**Re: Committee of the Whole Meeting of June 5th, 2018
Item 5.33
New Community Area – Block 27 Secondary Plan Study**

We are counsel to the Block 27 Landowners' Group Inc., the constituent members of which own the bulk of the lands subject to the proposed Secondary Plan. I have attached a list of the Group's Members.

SCHEDULE B BLOCK 27 LAND USE PLAN

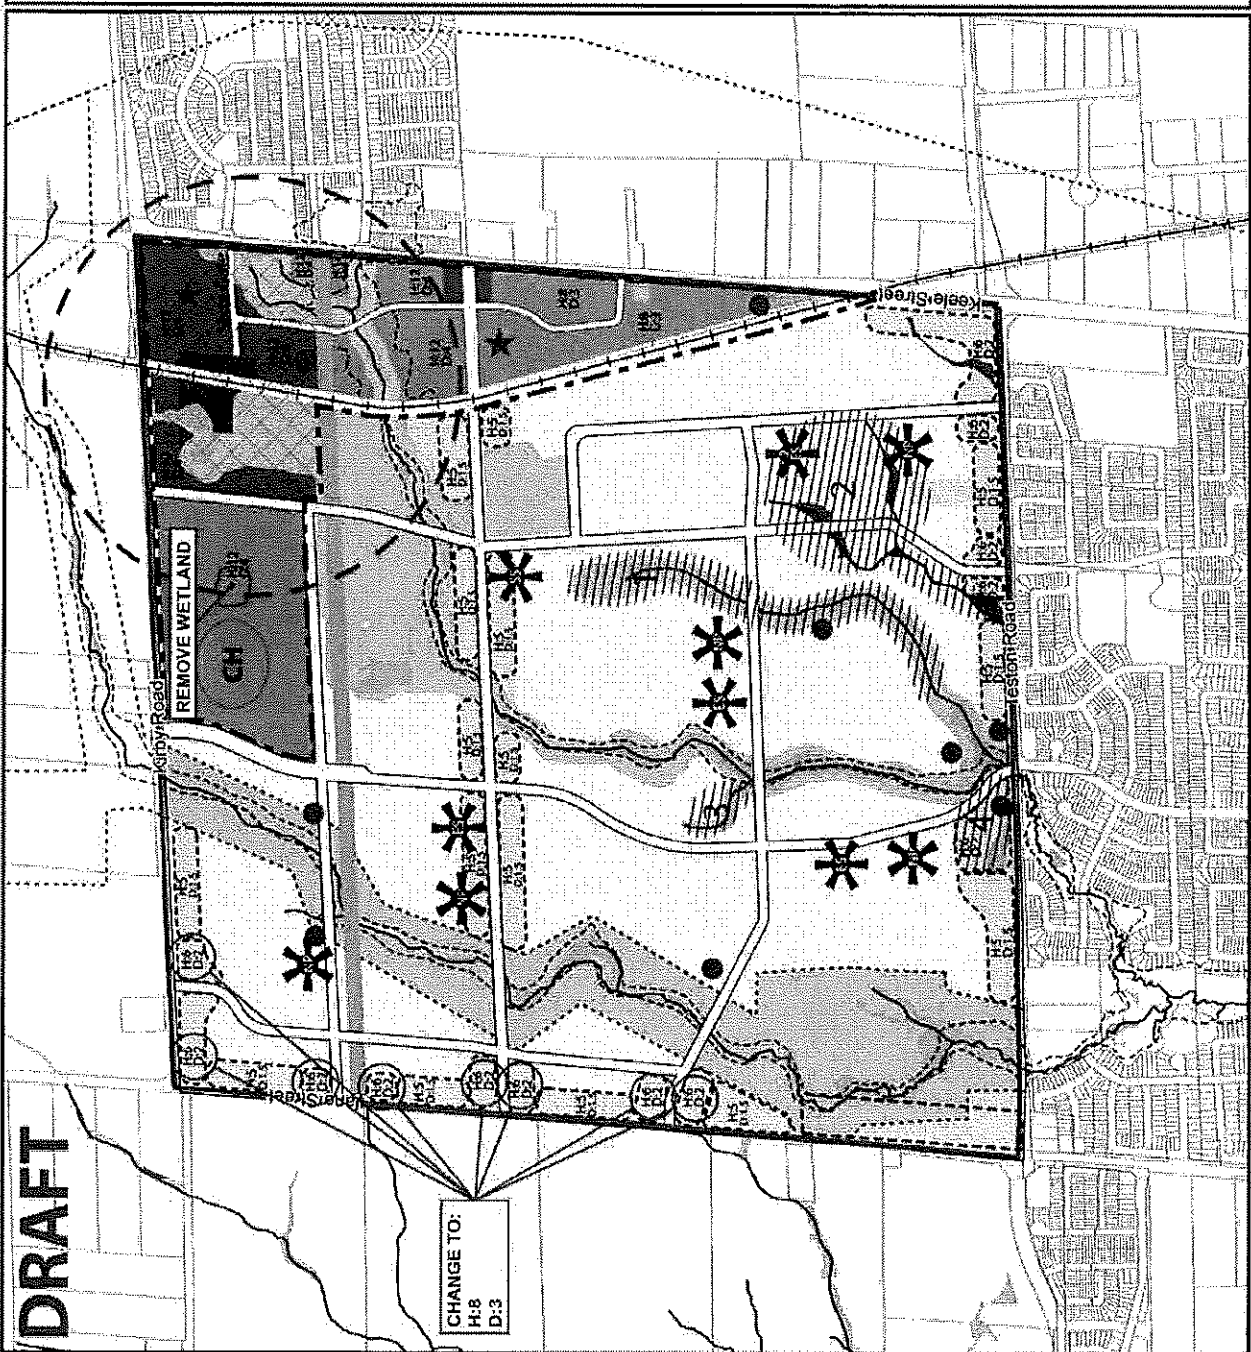
This policy should be expanded to increase the maximum building height and FSI at key intersections along Jane Street and Kirby Road to 8-storeys and 3.0 respectively. The following are our client's recommended changes (in bold and italics):

CHANGE TO:
H:8
D:3
